UNITED STATES PATENT AND TRADEMARK OFFICE

Office Action Summary	Application No. 10/568,812	Applicant(s) BODZAK, STANISLAW	
	Examiner TODD D. JACOBS	Art Unit 4159

DETAILED ACTION

Fig. 4

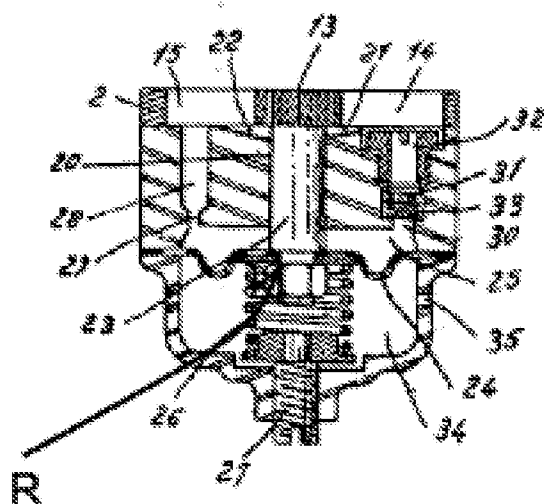
19. In re claims 19-21, as best understood, with reference to figures 2 and 4, Zenith discloses a connecting conduit (21) between the pressure chamber (25) and the intake chamber (14) embodied in the form of a groove let into a housing part facing the end surface of the at least one delivery element (5, 6) and the valve piston controls the passage through this groove.

20. In re claim 22, as best understood, with reference to figure 4, Zenith discloses that as pressure in the pressure chamber (25) increases, the valve piston (23) opens an ever greater through flow cross section in the connecting conduit (21).

21. In re claims 23-24, with reference to figure 4, Zenith discloses the diameter of the valve piston (23) greater than the width of the connecting conduit (21).

Fig. 2

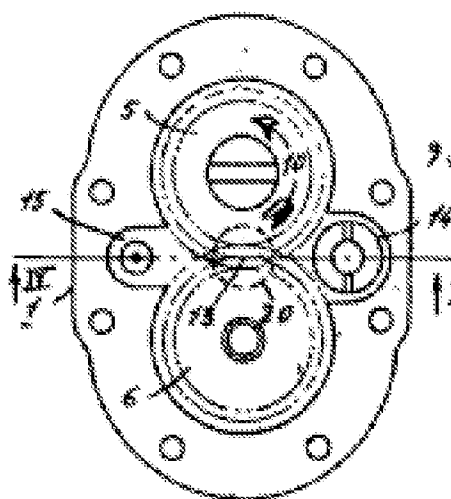
18. In re claims 15-18, as best understood, with reference to figures 2 and 3, Zenith discloses the valve piston (23) at least partially delimiting the pump chamber (13) in the direction of the rotation axis of the at least one delivery element (5, 6), wherein the closing spring (26) presses the valve piston (23) against the end surface of the at least one delivery element (5, 6) oriented toward it, which end surface functions as a valve seat, and wherein the

Fig. 3

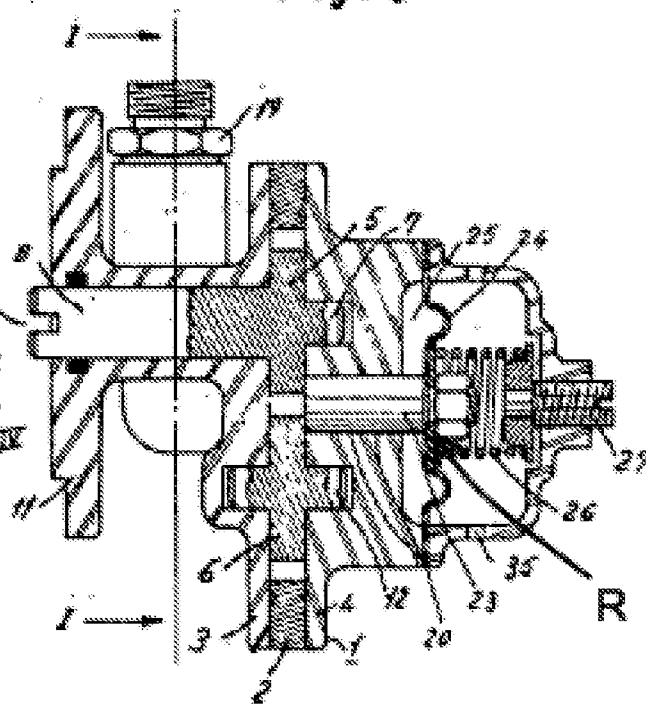
12. Nevertheless, Zenith, with reference to figure 3 below, describes a fluid pump with a pressure chamber (25) wherein the pressure prevailing in the pressure chamber (25) influences the force on the valve piston (23) in the closing direction in such a way that as the pressure in the pressure chamber (25) decreases, the force on the valve piston (23) in the closing direction increases. The advantage of this pressure chamber, as described by Zenith on page 1, line 34 is to "provide in a pump of this type an exact regulation of the pump delivery pressure".

15. In re claim 11, as best understood, with reference to figure 3 above, Zenith discloses the pressure chamber (25) delimited by a moving wall (24), one side of which is acted on by the pressure prevailing in the pressure chamber (25) and the other side of which is acted on by a prestressed spring (26) that pushes the wall (24) toward the valve piston (23) in its closing direction.

16. In re claim 12, Zenith discloses the moving wall (24) supported against the valve piston (23) by means of a rod (R).

17. In re claims 13-14, with reference to figure 3 above, Zenith discloses the moving wall (24) is embodied in the form of a diaphragm.
